UNITED STATES PATENT AND TRADEMARK OFFICE

APPLICATION NO.	FILING DATE	FIRST NAMED INVENTOR	ATTORNEY DOCKET NO.	CONFIRMATION NO.
09/800,006	03/06/2001	James C. Rush	STE01 P-1086	5256

Office Action Summary	Application No.	Applicant(s)	
	09/800,006	RUSH ET AL.	
	Examiner	Art Unit	
	Yvonne M. Horton	3635

DETAILED ACTION

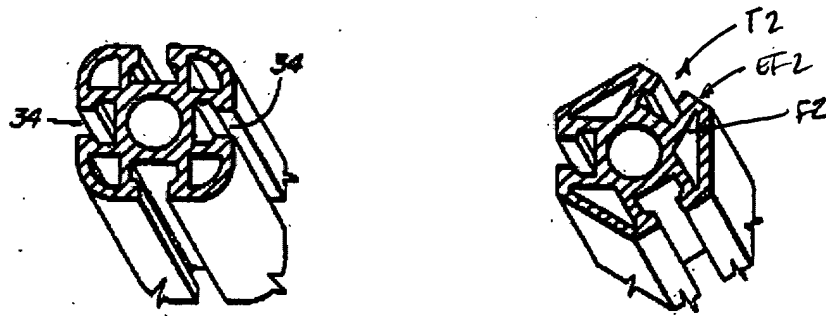
Claims 95-98 are rejected under 35 U.S.C. 102(b) as being anticipated by US Patent #5,277,512 to DWILLIES. DWILLIES discloses the use of a post and beam furniture system for partitioning open including a plurality of overhead beams/horizontal (10), each having opposite ends; a plurality of vertical posts (12), each having a lower portion thereof adapted to be abuttingly supported in a freestanding fashion on a floor surface of the open office space in a laterally spaced apart relationship, and an upper

portion thereof operably connected with the opposite ends of said overhead/horizontal beams (10) to support said beams (10) at a predetermined elevation above average user height; at least one of said posts (12) having a Y-shaped plan configuration (see figure 14D) defining three regularly spaced apart, outwardly extending flanges (F2), each of which has an end face (EF2) with a single T-shaped vertical slot (T2) extending centrally therealong (Column 8, lines 57-65); and At least two beam-to-post connectors (14,50) attached to the opposite ends of said beams, and detachably retained in said slot (T,T2) of aligned pairs of said flanges (F,F2) on said posts (12) to support said beams (10) on said posts (12) at said predetermined elevation. Regarding claim 96, DWILLIES further includes at least one partition accessory (91) having a mount (92)
